Intel[®] 413808 and 413812 SAS/SATA I/O Controllers

Specification Update

| Order Number: 315043-007US

Figure 8. VCC1P2PLLS0, VCC1P2PLLS1 Low-Pass Filter

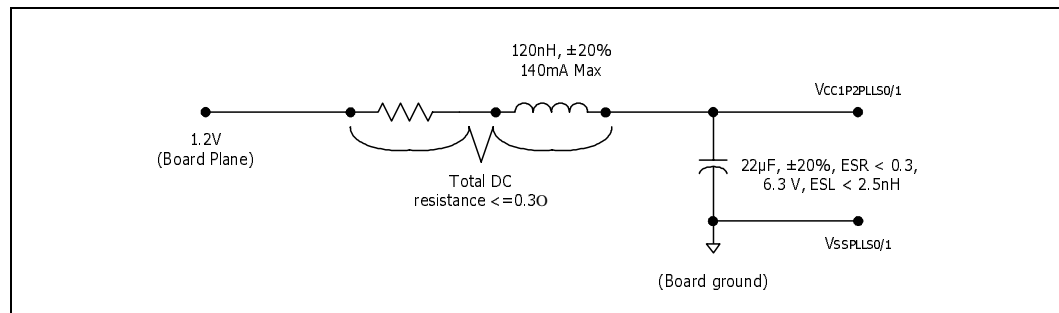
2. The VCCPLL Pin Requirements section of the Datasheet have changed

Problem: The VCCPLL Pin Requirements section of the Datasheet have changed. See below for the updates in Section 4.1 and Figure 8 in the Datasheet.

New wording for Section 4.1 - VCCPLL Pin Requirements (last two paragraphs):

This paragraph pertains to the VCC1P2PLLS0, VCC1P2PLLS1 filters. The recommended filter for the PLL supplies is shown in Figure 8. The purpose of this filter is to achieve at least 10 dB rejection of frequencies between 1 and 20 MHz. The board supply distribution system must ensure that the minimum voltage into the PLL ball is equal to or greater than 1.164 V. The current draw for the IC is 95 mA typical less than 140 mA maximum. The filter components are selected to achieve a corner frequency of 100 KHz. The series resistance keeps the Q of this resonant circuit safely below unity for all component variations. The total DC resistance of the resistor and the inductor must be equal to or less than 0.3 Ohms.

The bypass capacitor must be placed as close to the supply pins as possible. The series impedances to both the supply pin and the PCB analog ground plane must be an order of magnitude lower than the ESR and ESL specified for the capacitor. The S0/S1 PLLs have dedicated internal supplies, so the VSSPLLS0/S1 pins must be soldered directly to the analog ground plane of the PCB.

New Figure 8:
